MEMORANDUM

From:	Built Heritage Officer		
Service	Green Infrastructure	App No:	242577
Address:	South Scarletts, Scarletts Lane, Hare Hatch, Wokingham, RG10 9XD		
Proposal:	Application for listed building consent for the proposed erection of a single storey side extension with installation of roof lights, following the demolition of the breakfast room.		
Heritage Assets:	Scarletts – Grade II listed building Listed buildings along with conservation areas are classed as designated heritage assets under the NPPF (2024) and in the Council’s Local Plan policies.		
Site Visit Made:	Yes

Proposed Internal East Elevation
Scale 1:20

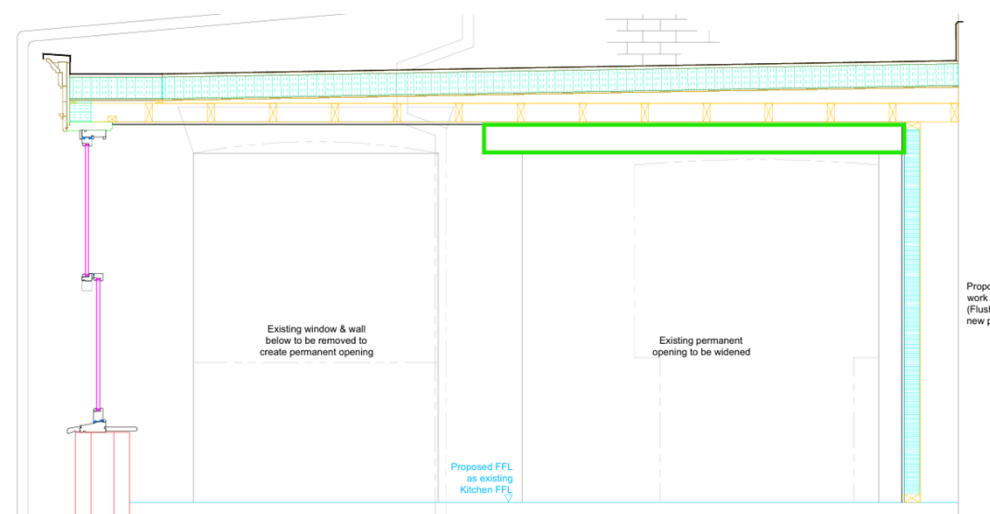
- Details concerning the two rainwater downpipes have now been clarified and acceptable, under drawing 12940/10A and 12940/09B
- Section drawing ref 12940/11A has been submitted in regard to structural steel to be inserted as to support the enlarged opening. However, this drawing implies the loss of the brick arch above the extant window if the steel is the span the whole width (red shape added to drawing 12940/10A to indicate steel):

- As drawing 12940/11A shows, the cross section of the steel is almost the full depth of the walling, and as (presumably the bricks for the arch have a standard c10mm measurement) there wouldn't be enough room to retain the arch and insert the steel – is this the proposal? Or is it proposed to only span the newly increased opening and not the window – something along the lines of this (green shape added to indicate steel):

Proposed Internal East Elevation
Scale 1:20

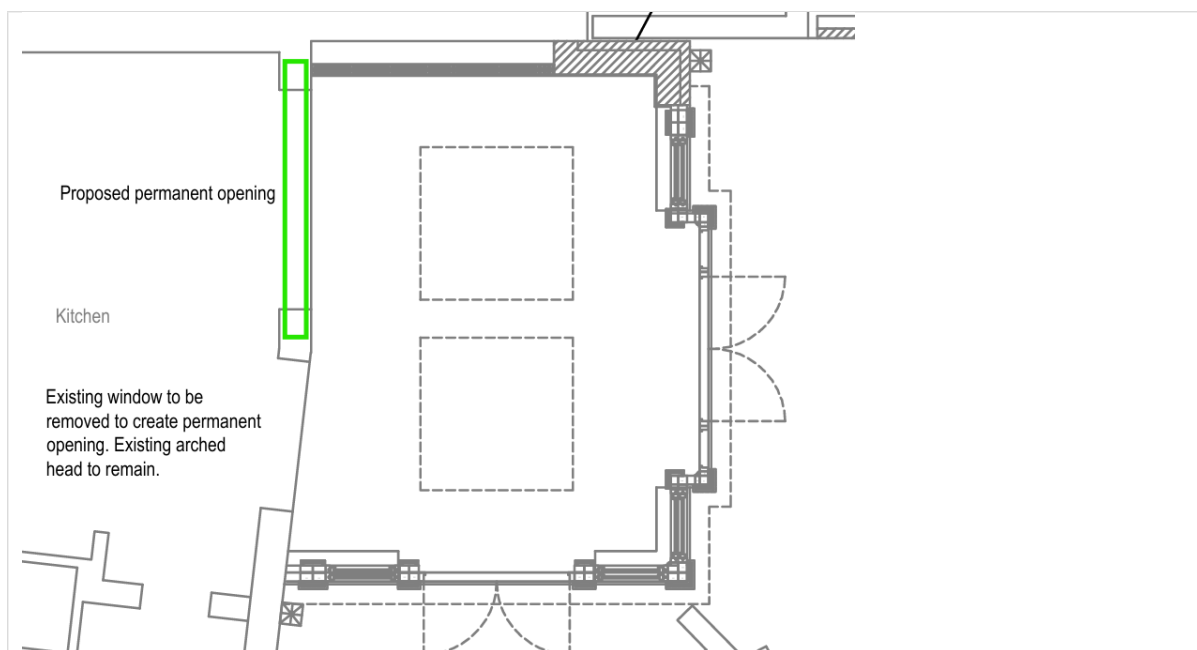
- If this latter option is the proposal, please could the drawings be revised as to include this for absolute clarity. As the walling kinks off, it is presumed a single span wouldn't work here in any regard. Furthermore, as the brick arch of the window is designed to take the load, and only a limited additional load is being proposed to be added, it – presumably – has sufficient structural capacity as extant.
